TECHNICAL BULLETIN

Q561NAS1

Service Action: Windshield Finisher Coming Loose - Detaching

LR4 (LA)

E180679

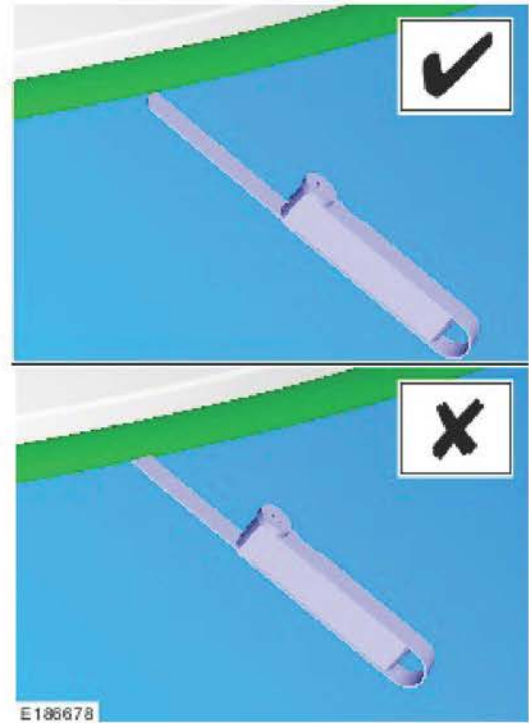
1. Check the upper windshield finisher for potential wind noise/leak paths (2).

2.  **NOTE: at least 5mm of the tip of the plastic feeler gauge or more needs to pass under the finisher to be considered a fail.**

Using a 0.1mm plastic feeler gauge (or similar), probe perpendicular to the finisher at equally spaced increments.

- If the tip of the feeler gauge (or similar) passes less than 5mm under the finisher at equally spaced increments, release the vehicle.

- If the tip of the feeler gauge (or similar) passes more than 5mm under the finisher at equally spaced increments, continue to Step 3.
